**SUPPLEMENTAL INFORMATION FOR THE WALNUT CREEK ENERGY PARK
APPLICATION FOR CERTIFICATION (05-AFC-2)**

In Response to Data Adequacy Review

Walnut Creek Energy Park

(05-AFC-02)

Power Flow Diagrams

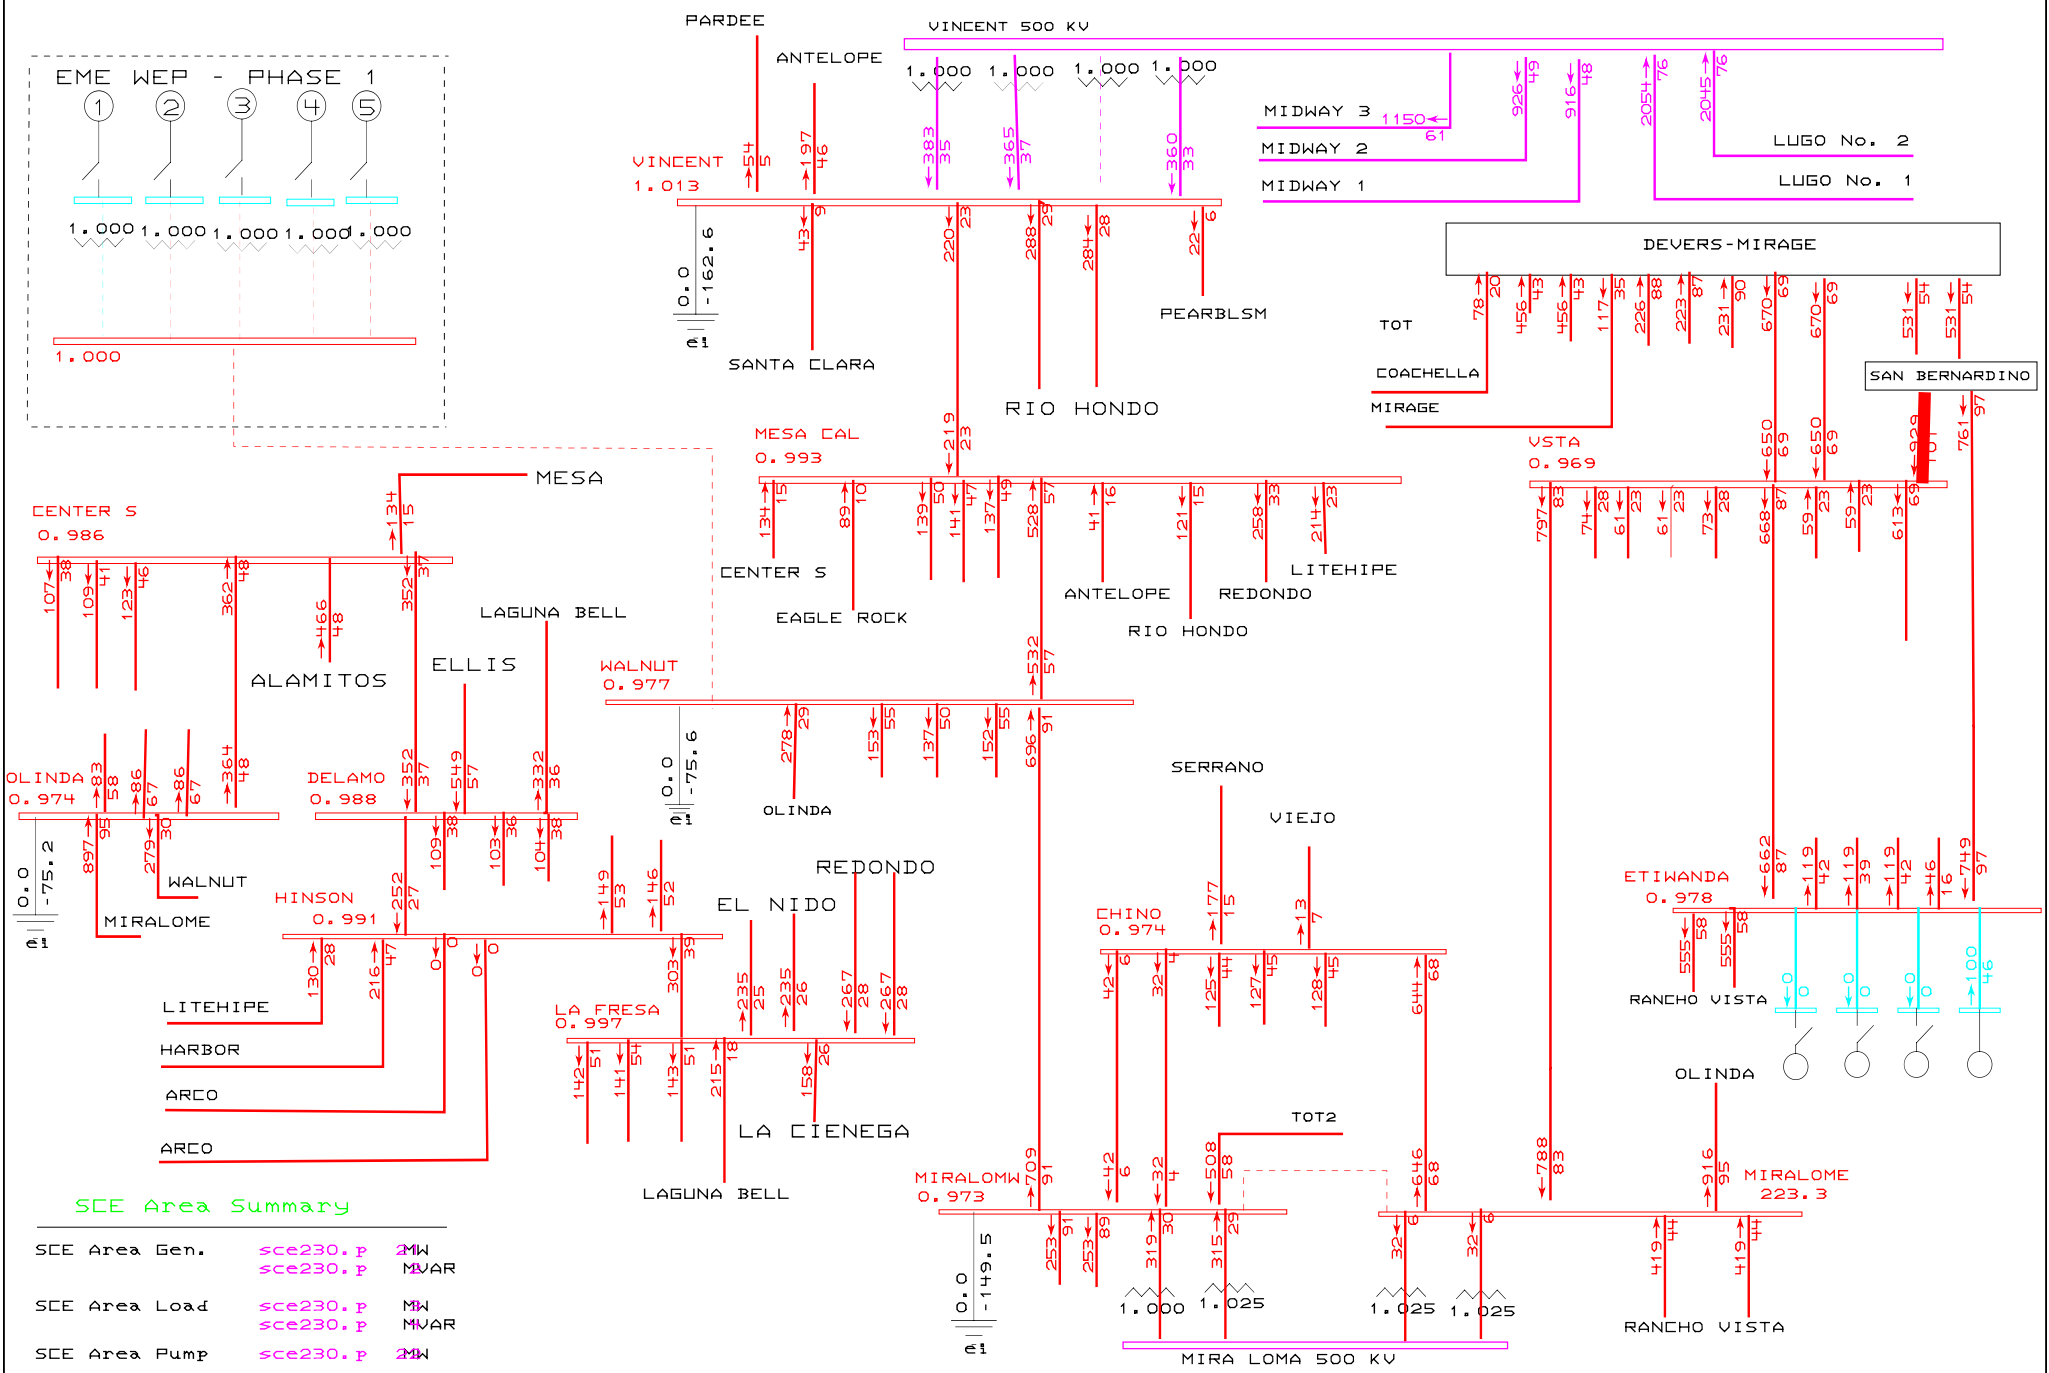
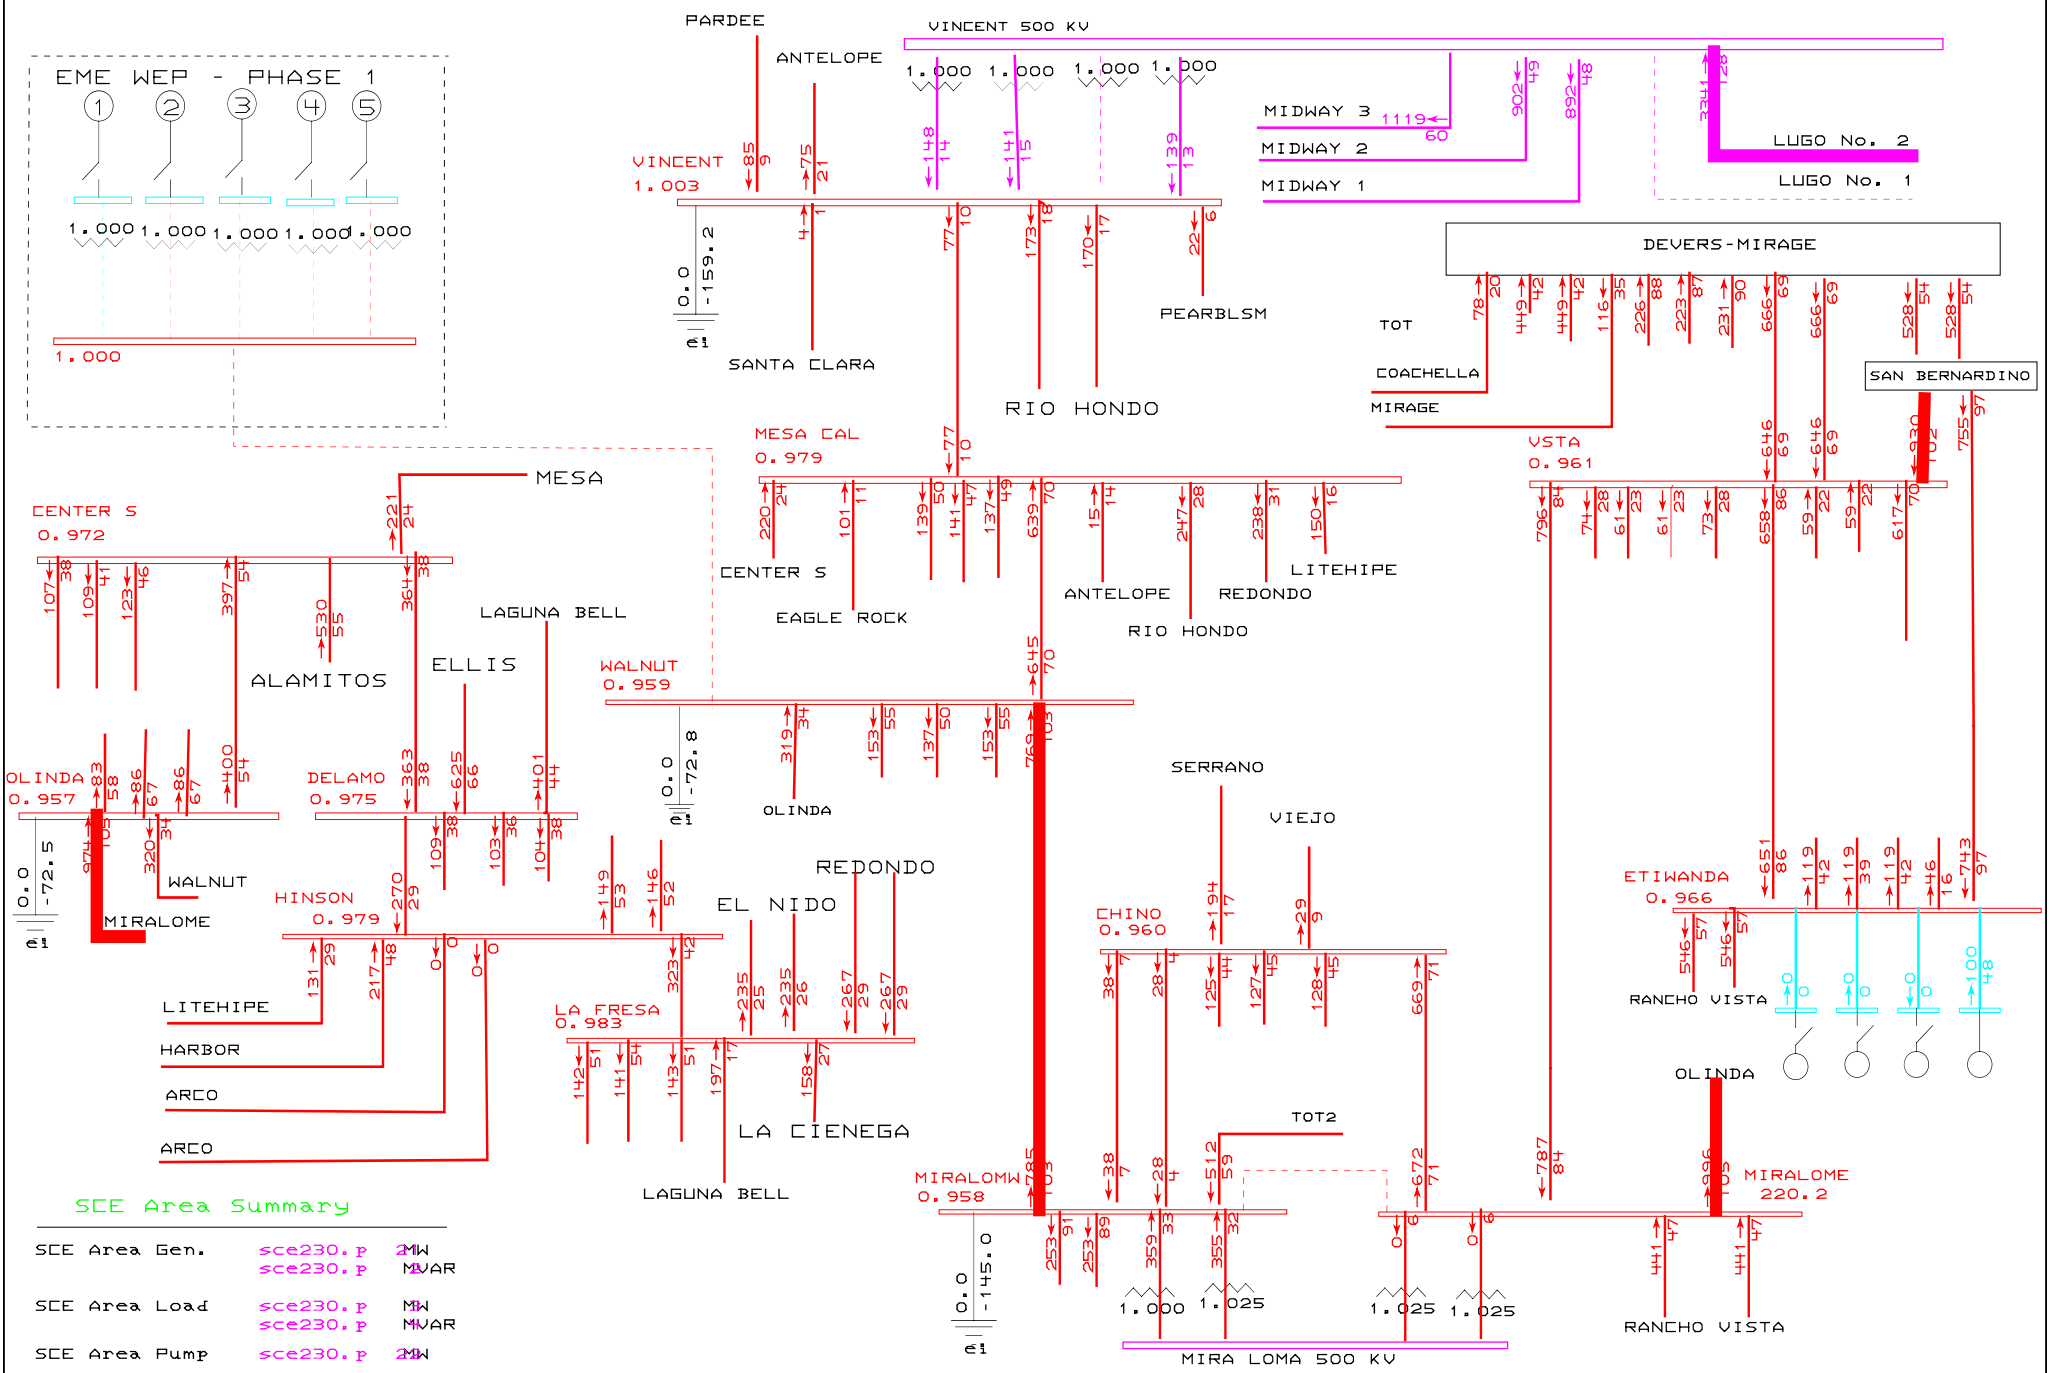
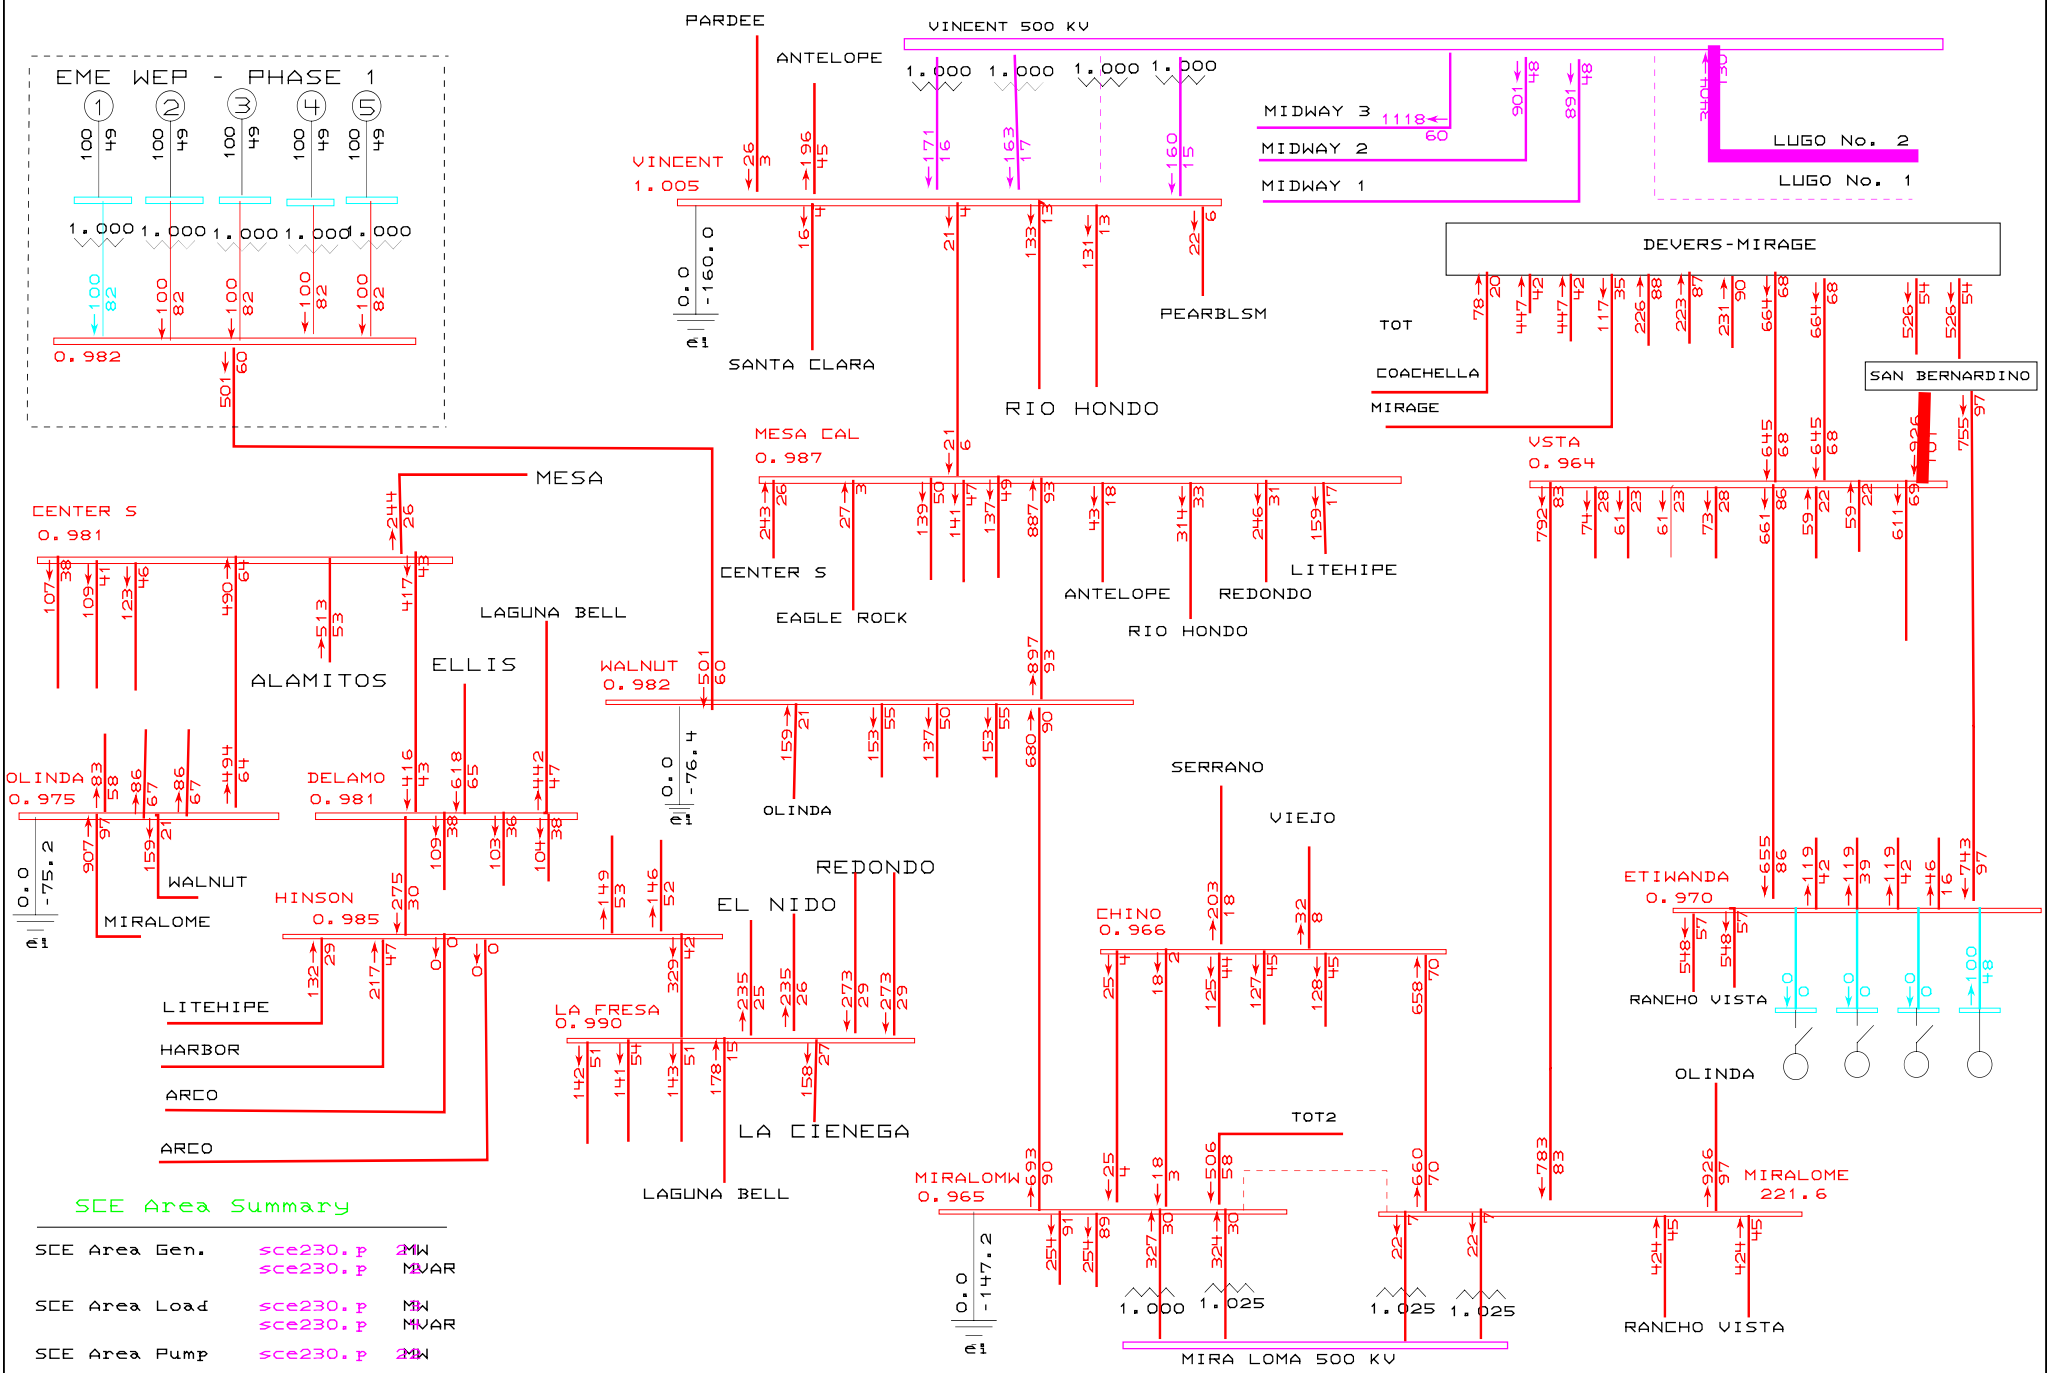
Provide power flow diagrams (MVA, % loading & P. U. voltage) for all N-1 and N-2 contingencies where overloads or voltage violations appear.

Response – Power flow diagrams for cases for which the WCEP would aggravate existing transmission system overloads are attached.
